Current proposal for J1979-2 First Frame Escape Sequence

5-12-20

#2 >4k NRC 14 - escape sequence is not supported from Server

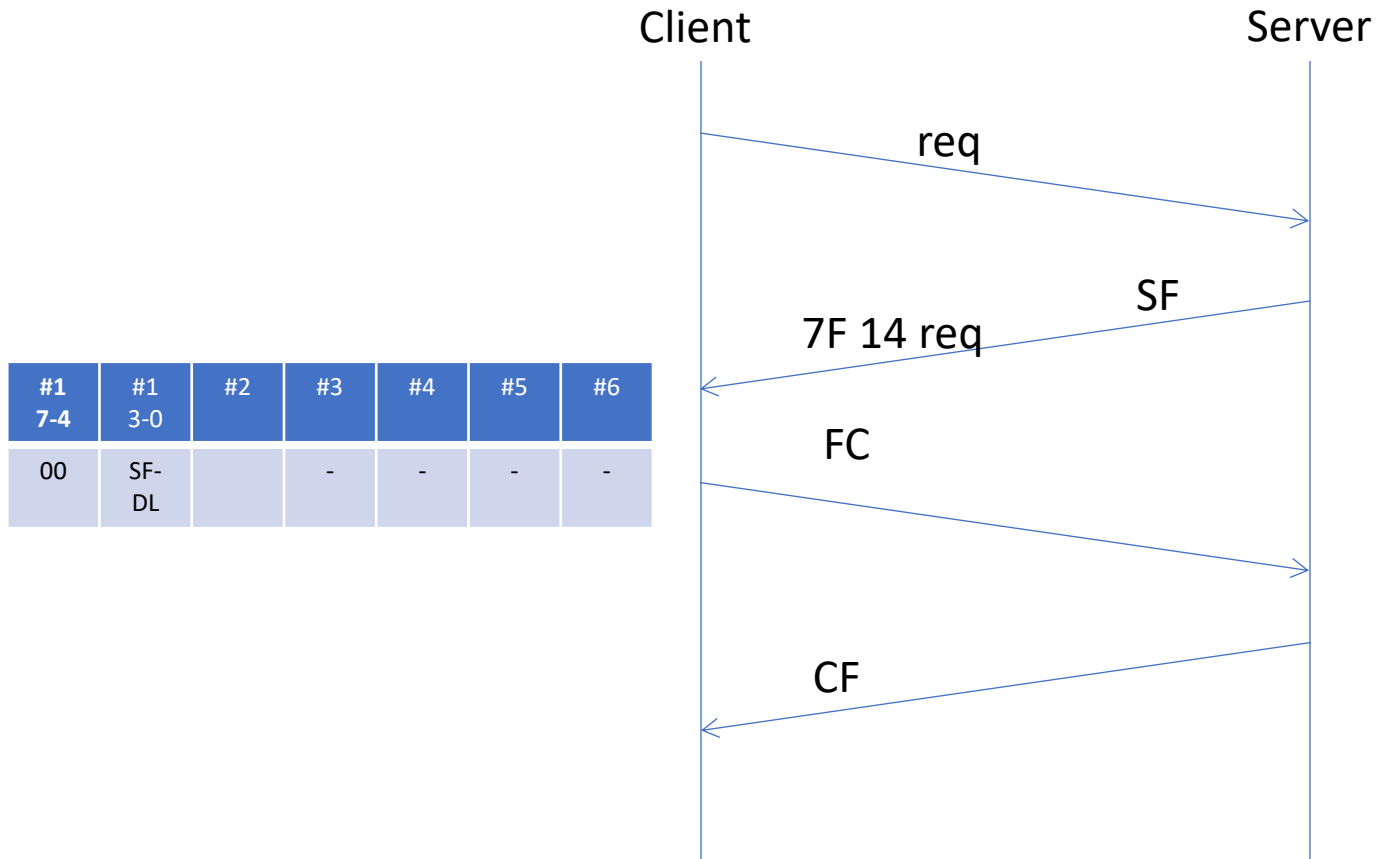
- Open points:
- NRC 0x14 is no longer required. Do we really need to keep it in SAE J1979-2? We don't have a allowed use case, and sending of NRC 0x14 will against the standard.
- FF esc sequences allows up to 4GB messages,
- but 8/16/32KB will probable be the practical limit (supporting up to 2000/4000/8000 DTCs). Should be a requirement for minimum size in SAE J1979-2 and J1978-2? What happen if the size increase with Number of DTCs or new functionality?

- Recommendation: Mandatory for Server and Clients.

ISO 15765-2/ISO 15765-4 #3 >4k FirstFrame escape sequence is supported from Server and Client

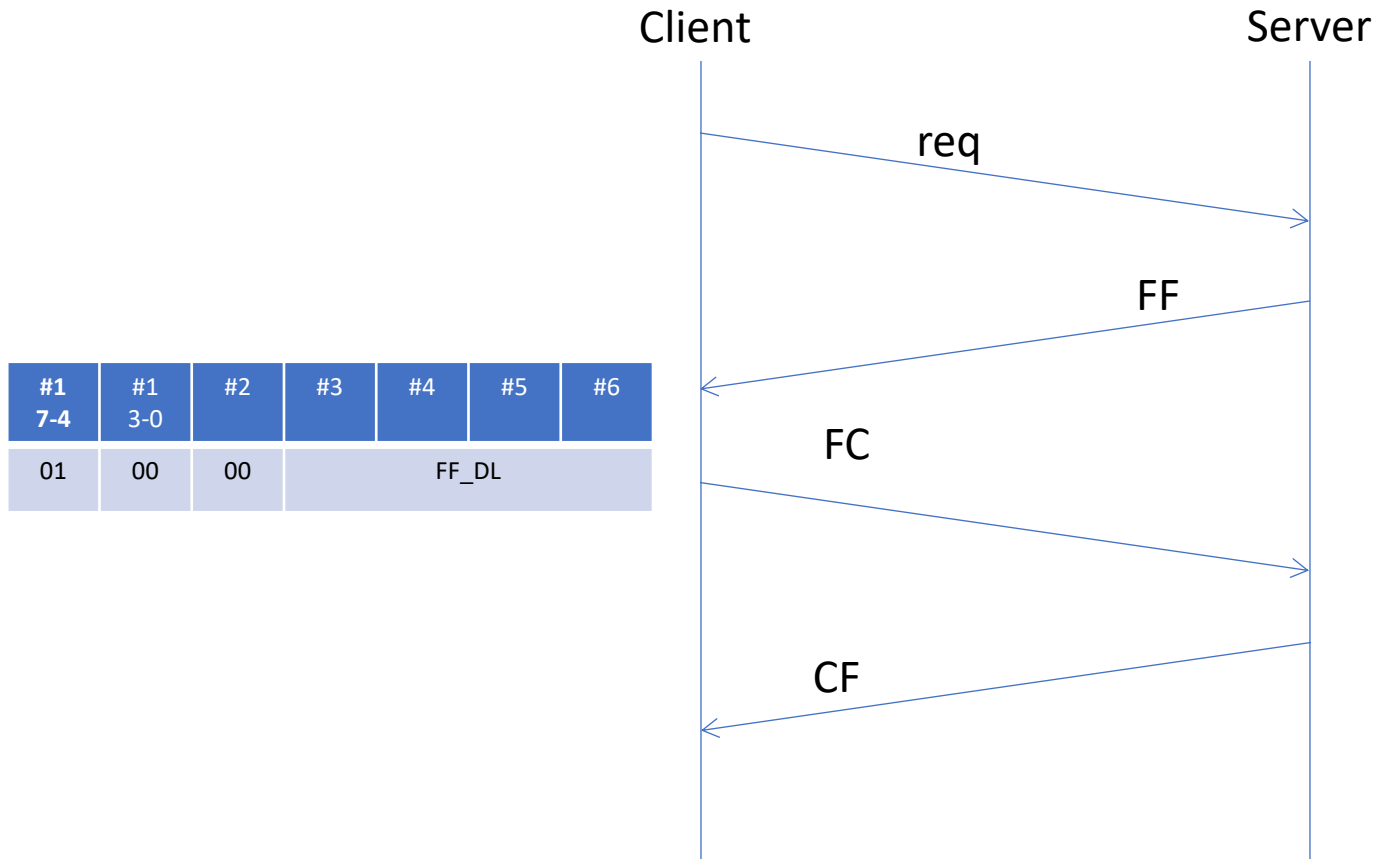
4GB is possible but 8/16/32KB* is more probable.

*have to be defined from industry

sequence #4 >4k Client not supporting FF escape sequence

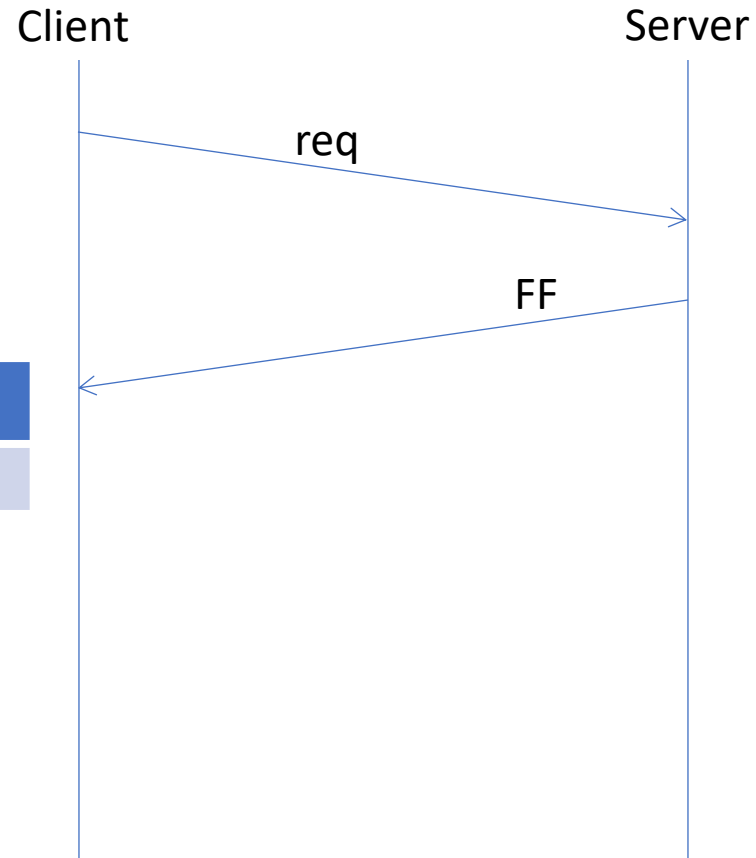
- If it is agreed for introduction of J1979-2 then all Clients and Server must support it.
- It is only used when message > 4k on DoCAN.
- If a Client does not support it (violating requirements) then it will see no response from the ECU
- And should re-send the latest request. (with delay?).
- It is difficult to detect which Clients do not support it.
- If Server not support it, it will send an Negative Response Code 0x14.

Message is dropped.
Application will see no response
